ZONING MAP CHANGE STAFF REPORT

Site Location: 3860 Tanacross Drive Acreage: 2.30

Proposed Use: Multifamily

Request: From: "G" Intensive Commercial

SP-100

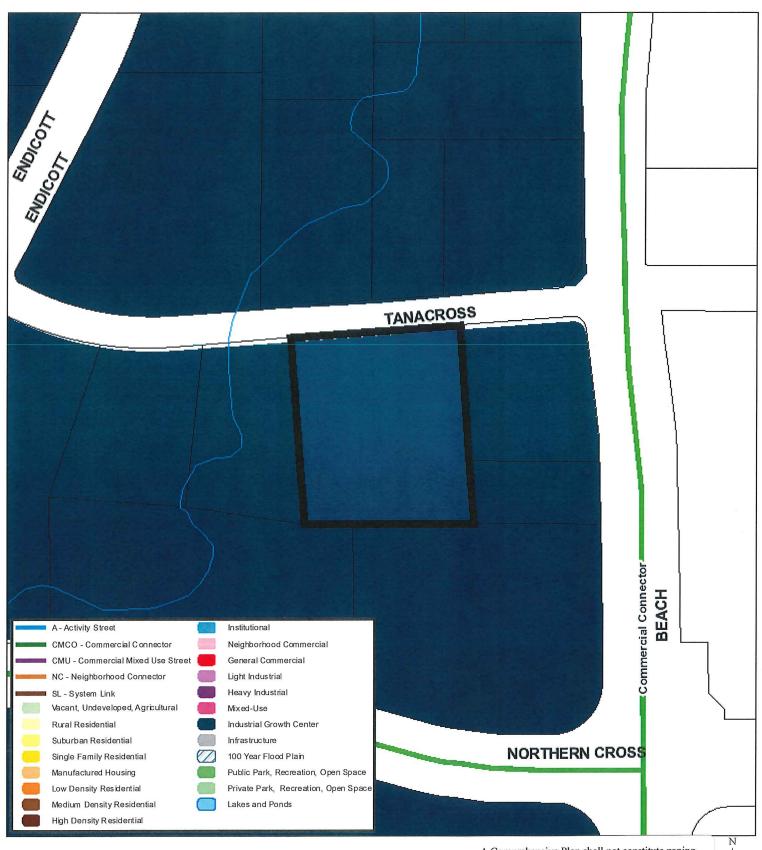
The site plan as submitted is not in general compliance with the Zoning Ordinance regulations.

- Maximum units per acre is 32, site plan indicates 52 units per acre. (recommended Development Regulation Standard)
 - (analysis: Based on the need for additional units needed for the project) Staff supports the additional units per acre.

- Front yard setback needs to be a 20 ft. setback, no parking or structures within the setback, signage and parking located within this setback. (recommended Development Regulation Standard)

- 3. Maximum height 35 ft., existing structure is 49". *(recommended Development Regulation Standard)*
 - (analysis: Based on the use of the existing structure the development regulation standard applies) Staff supports the height based on use of the existing structure.

- MFD Multifamily Development submission required. (recommended Development Regulation Standard)
 - (analysis: This is not the typical multifamily development) Staff supports the request to not submit the MFD for multifamily development.

- 5. The longest end of the building should run east and west. *(recommended Development Regulation Standard)*
 - (analysis: Based on the existing building orientation the longest end is north and south facing the street) Staff supports the request based on the existing building configuration.

- 6. The existing building is unable to meet the façade requirements. *(recommended Development Regulation Standard)*
 - (analysis: Based on use of the existing structure) Staff supports the request based on use of existing structure.

- 7. Minimum open space requirement is 35%, site plan indicates 31%. *(recommended Development Regulation Standard)*
 - (analysis: Based on use of the existing site there is no room to obtain more open space) Staff supports the request based on use of existing site.

- (analysis: Based on use of the existing structure and configuration of parking and signage, the development regulation standard applies) Staff supports the request based on use of the existing structure.
